Model : GP605

Ref. No. : FF-T01-K1-000020-UK2

Location : ADF PICK-UP ASSEMBLY

Subject : MEASURES FOR THE FOLDING OF THE DOCUMENT'S LEADING EDGE IN THE ADF

Fig. 1

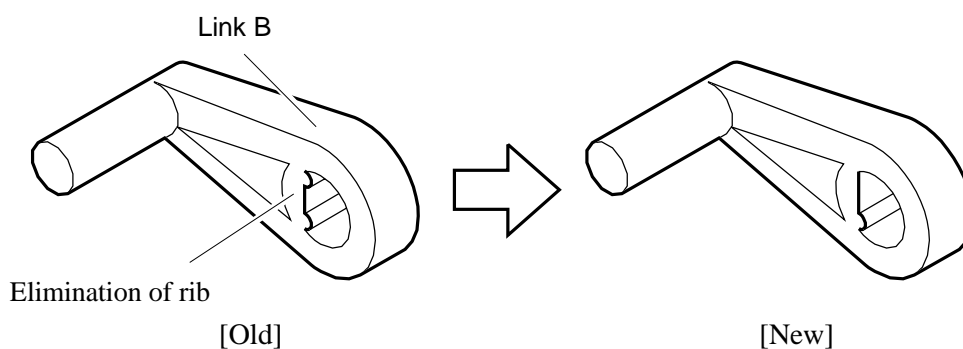
- In case the accumulated tolerances of the parts get too close to the limits, the document may strike the copyboard glass and the document's leading edge may become folded.
- The reversing flapper is replaced as the measure to deal with the situation of breakage consequent to the user getting his fingers caught to the reversing flapper in clearing a jam. But failing to notice during the replacement that the reversing guide has not been completely pushed in and properly seated could result in the document's leading edge to become folded.

By eliminating the rib of link B (Parts Catalog TY8-31DV-000 page 30-97) and changing to the type with a different angle, the folding up of the reversing flapper was restrained, and the striking of the document against the copyboard glass prevented.

Fig. 5

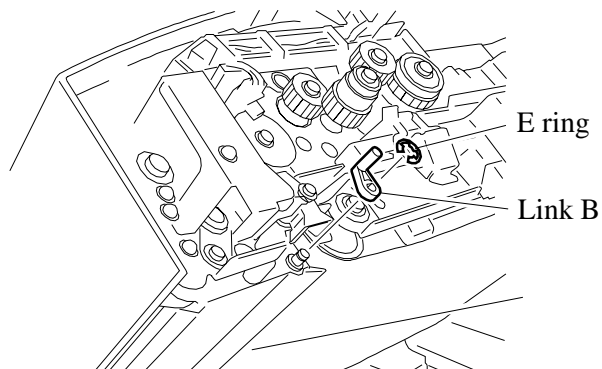
- 4) Remove the E ring, and replace link B (Fig. 5).

New Part FB4-7628-020

Fig. 6

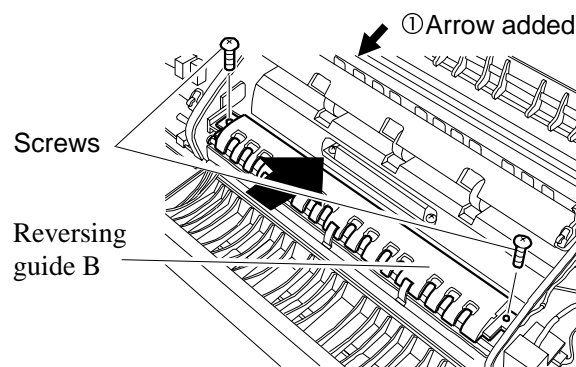
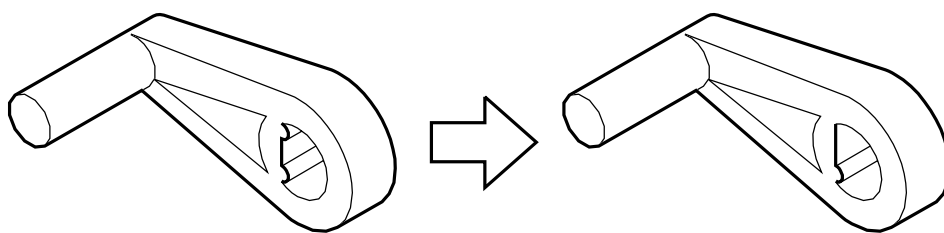
- 5) Open the registration guide, loosen the 2 screws and push in the reversing guide B in the direction of the arrow until properly seated, and then re-tighten the screws (Fig. 6).
